SERVICE MANUAL LEVEL 1 Rev 01 – ADDENDUM 9

Updated to Sapphire 13.21.1 and 13.22.1, SapphireH100 13.22.3, SapphirePlus 13.11.1

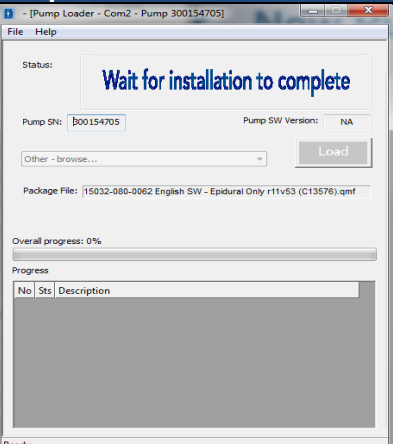
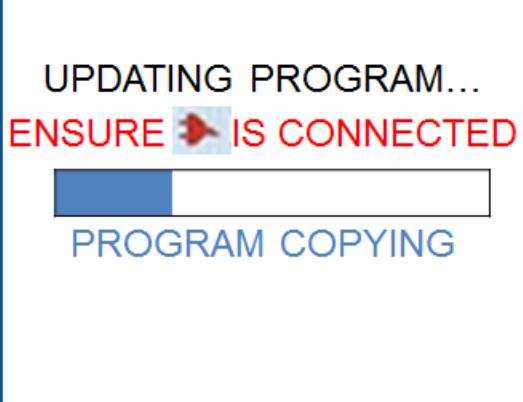
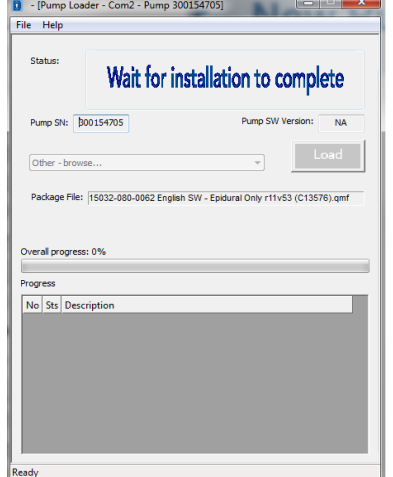
4. The main screen of the Pump Loader appears. After a few seconds the **Status** field should indicate **Pump connected**. If the status field indicates **No device connected** verify that the pump is connected properly to the computer via the correct COM port.
In case of communication problems refer to the troubleshooting section below.

The main screen of the Pump Loader includes the following fields (see figure below):

Software update in process

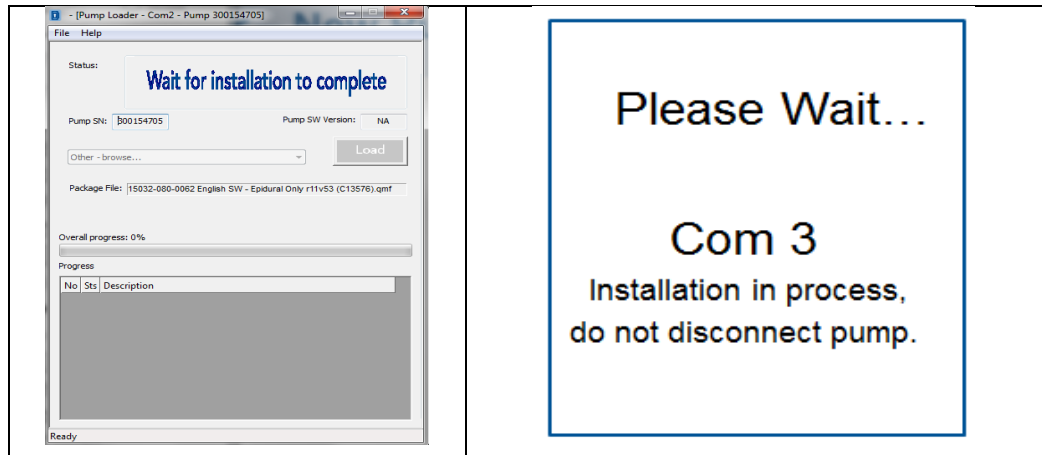
During the update process, after the boot mode, the following screens appear on the computer and on the pump:

Software update completed

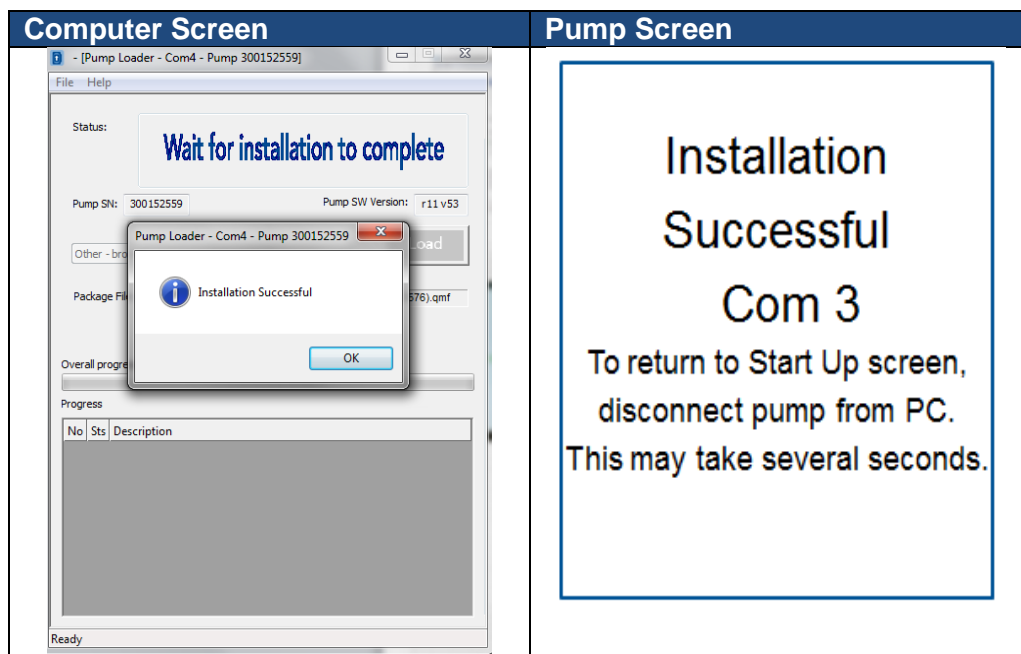
6. The pump software update is completed when a message stating the update was completed successfully is displayed on the computer and on the pump. See picture below.
